MEETING AGENDA
CITY PLAN COMMISSION
Wednesday, May 8, 2024
Work Session 9:00 a.m.
Public Hearing: 10:00 a.m.

- 1. **PP-19-008 Tradition Central and Southern Phases: (Revision/Waiver Request): 2,307 Single-Family Detached Residential Lots and 79 Private Open Space Lots. ETJ-Denton County.**
 - a. Being approximately 780.76 acres situated in the Guadalupe Cardinas Survey, Abstract No. 214, located in the City of Fort Worth, Tarrant County, Texas.

2. **PP-21-045 Normandy Farms: (Revision): 127 Single-Family Detached Residential Lots and 10 Private Open Space Lots. Council District 10.**

PRELIMINARY PLAT
 FOR
TRADITION, CENTRAL & SOUTHERN PHASE
 BEING
 780.716 ACRES
 SITUATED IN THE
 GUADALUPE CARDINAS SURVEY,
 ABSTRACT NO. 214
 IN THE
CITY OF FORT WORTH,
DENTON COUNTY, TEXAS
 APRIL, 2024
SHEET 2 OF 2

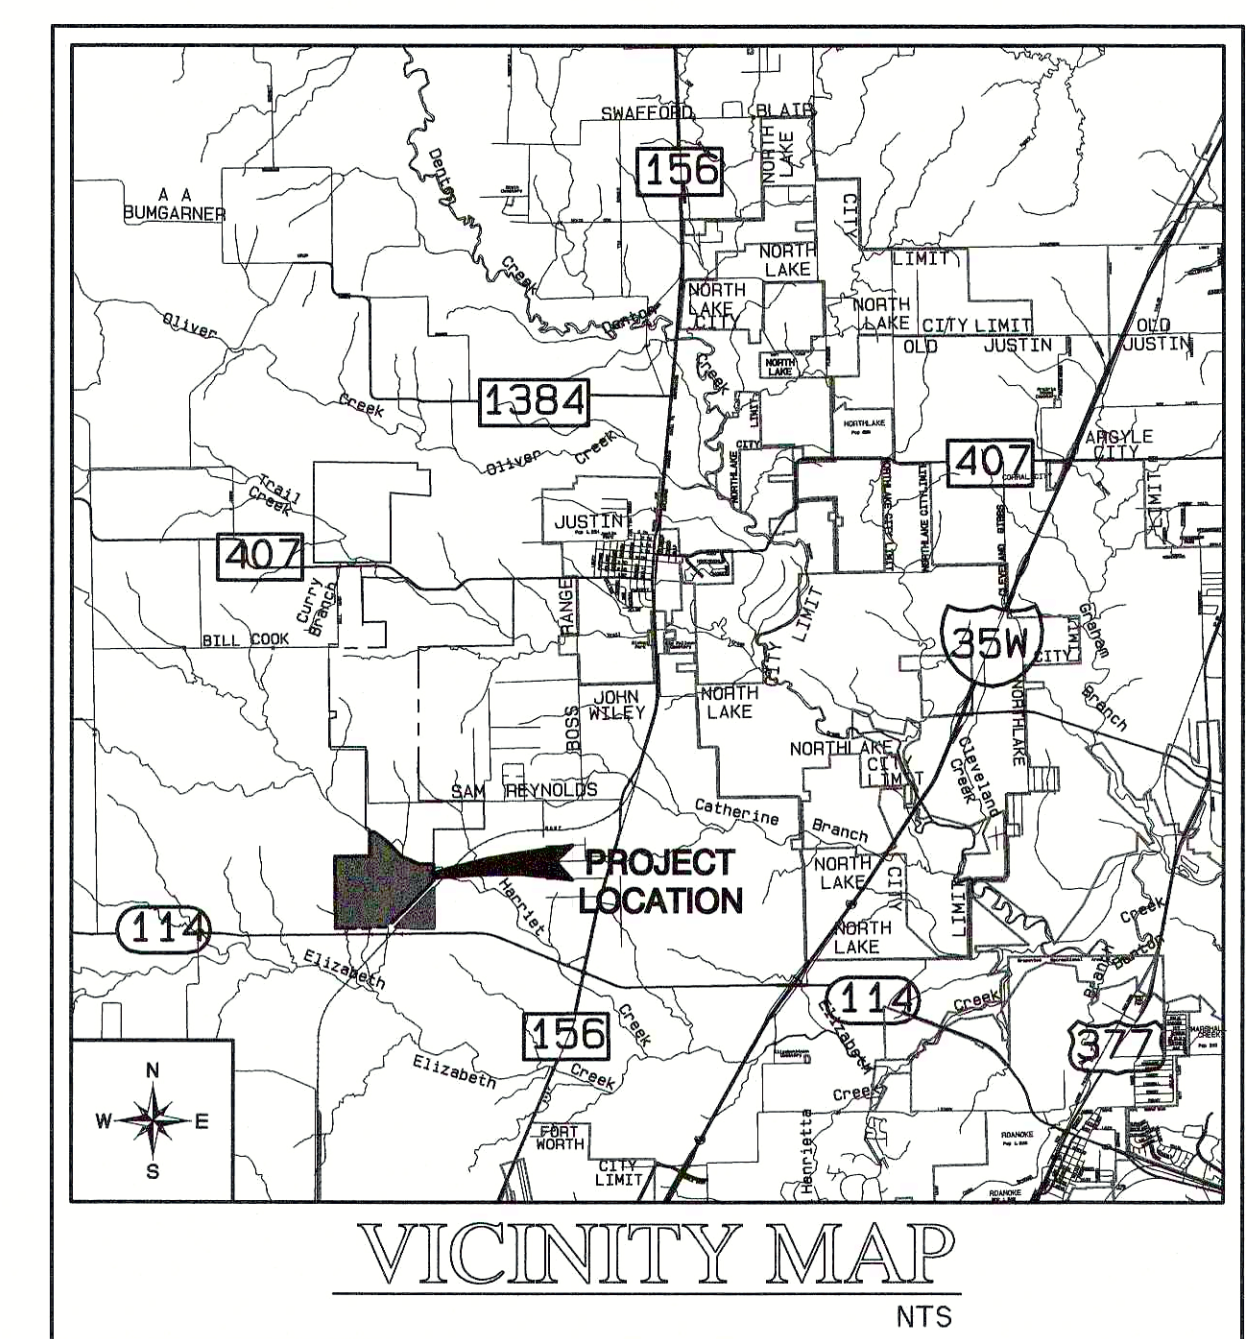
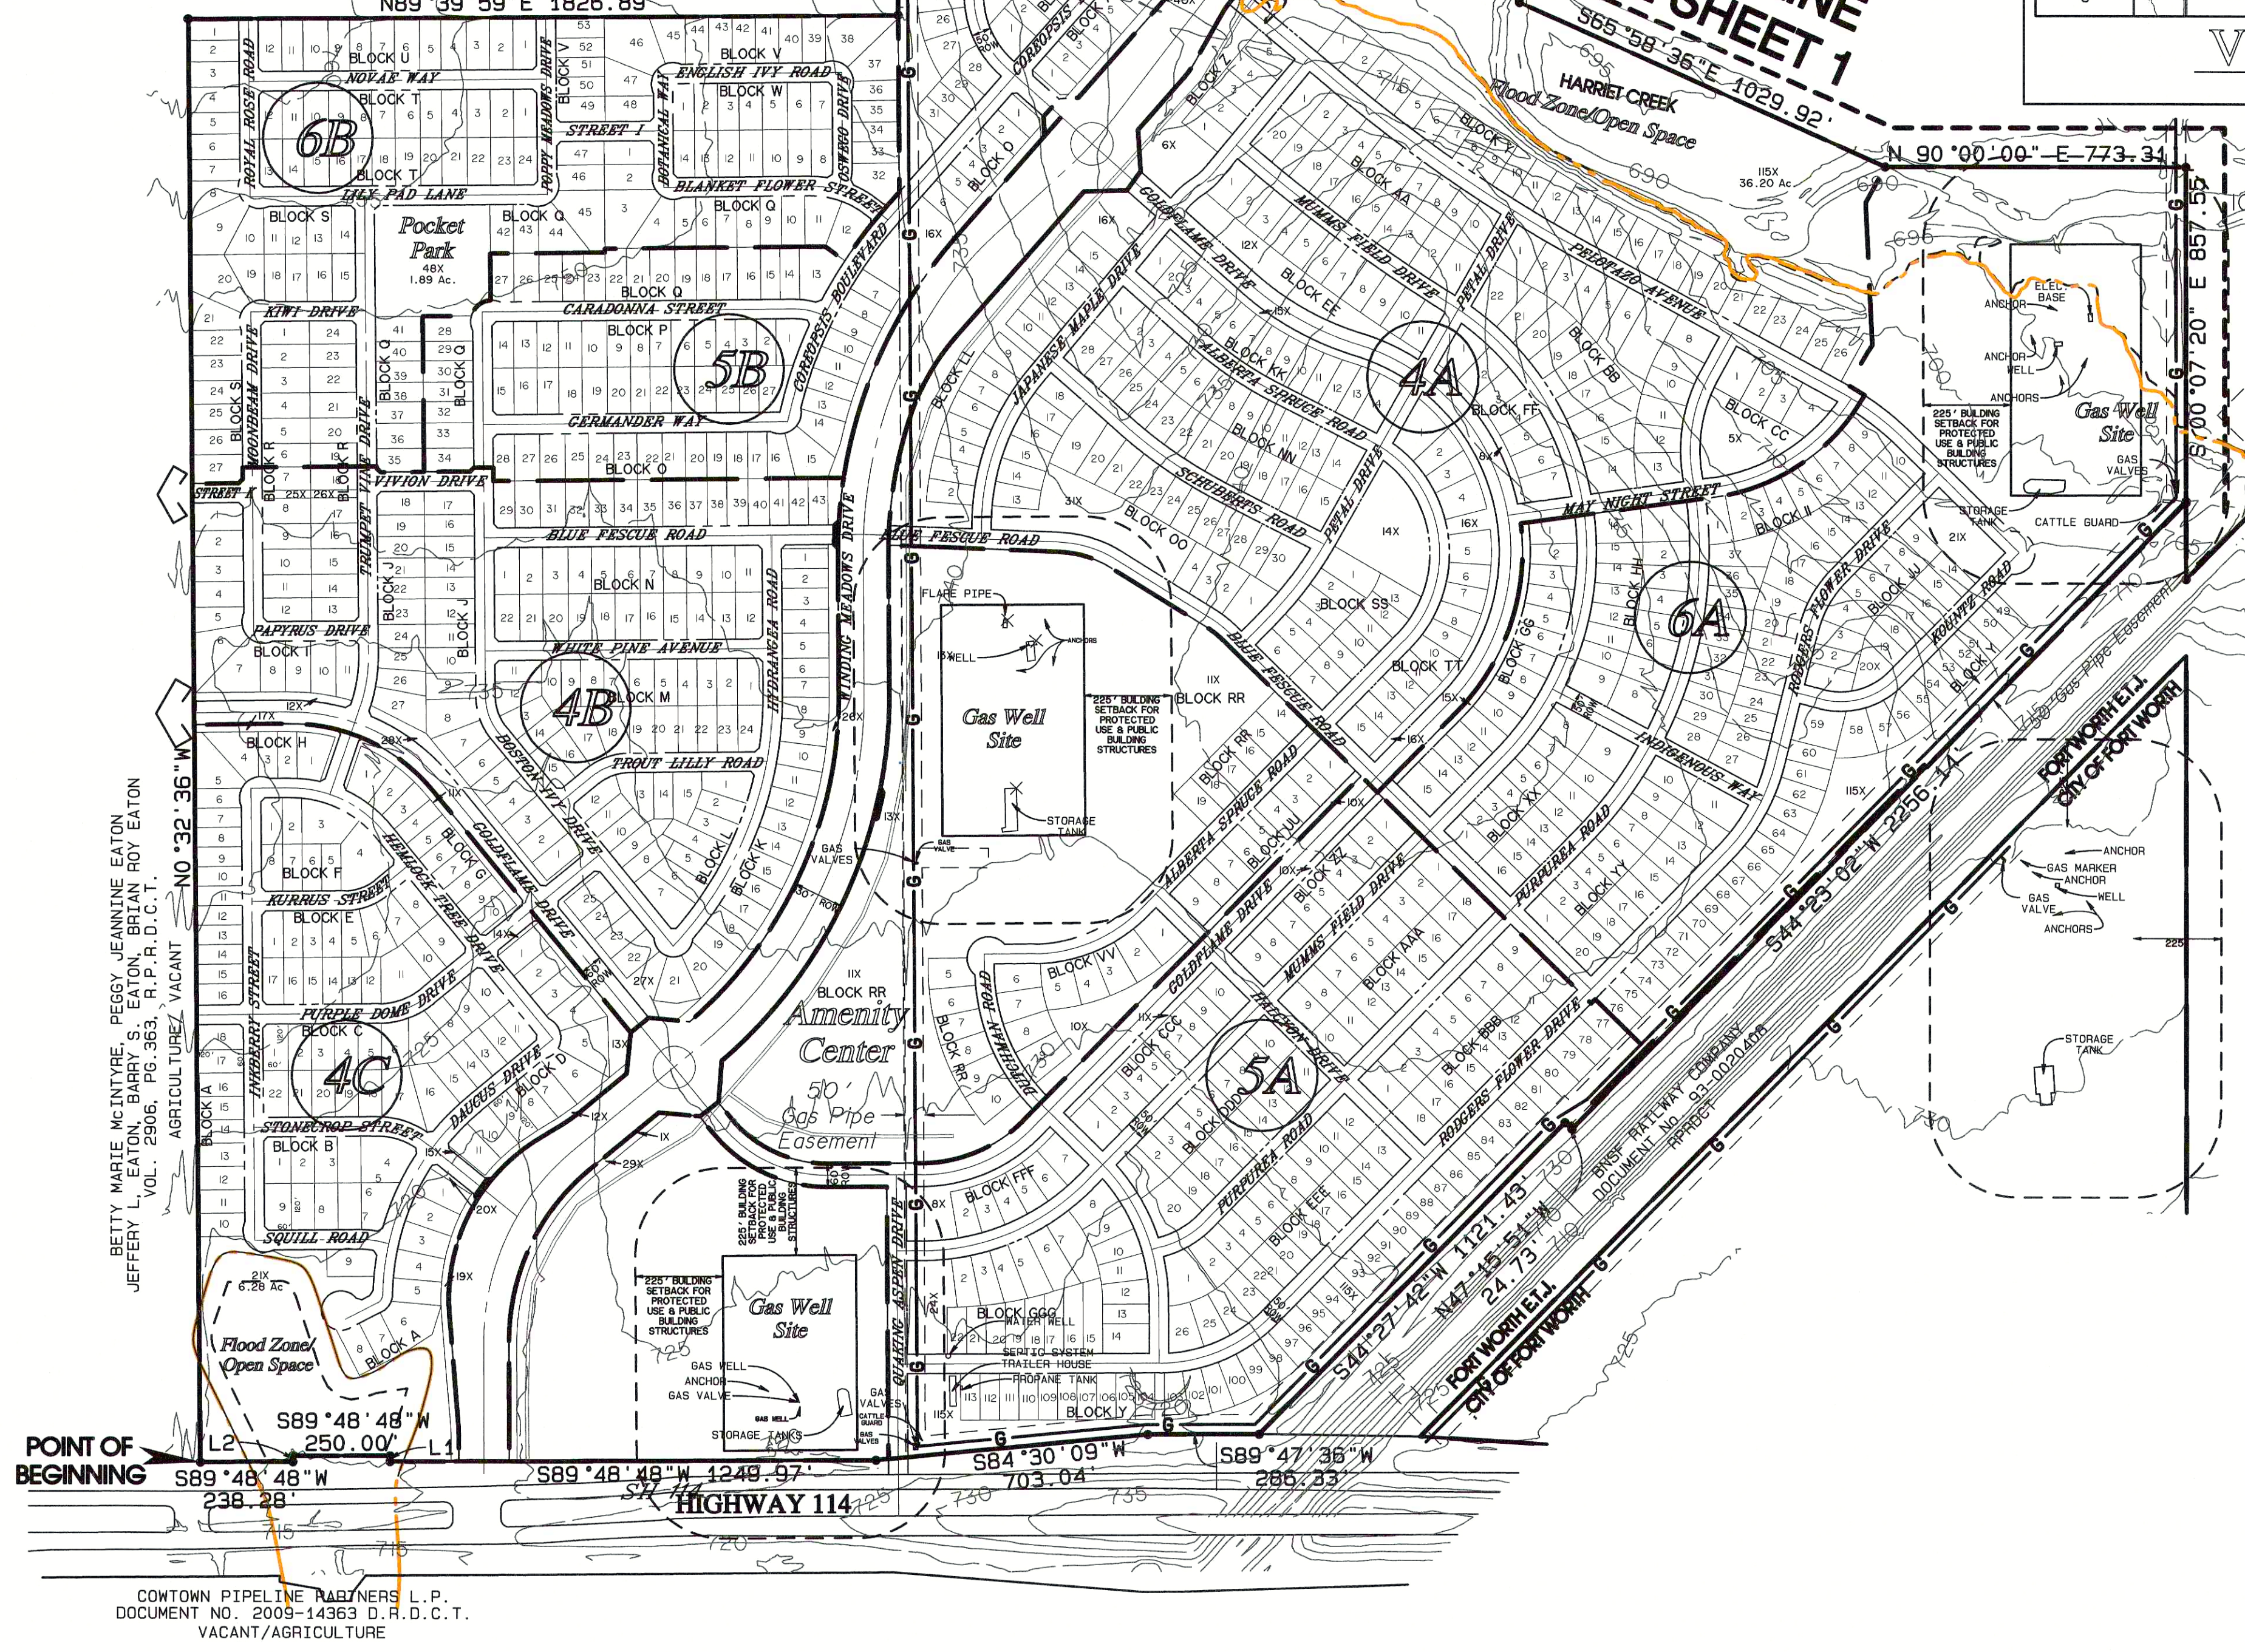
The revised preliminary plat includes one additional block face length (Block RRRRR, Lot 1-Lot 18) that exceeds the maximum allowed 1,320-foot block face requirement. The applicant has requested the block length waivers citing that an elementary school site and existing floodplain adjacent to the Phase 3D parcel creates the long block.

the total no. of residential lots proposed in the subdivision has increased to a total of 3331. However, as per the approved Development Agreement, # 47477-A2, a maximum of 3284 residential units shall only be permitted. In this regard, the new Preliminary Plats PP-23-013 and PP-19-008 for the proposed development of TRADITION SUBDIVISION cannot be accepted until the agreement is amended or drawings are revised to conform with the agreement.

Provide a block face table wrt revision with all block faces measured, as shown in S.O., Section 31-106
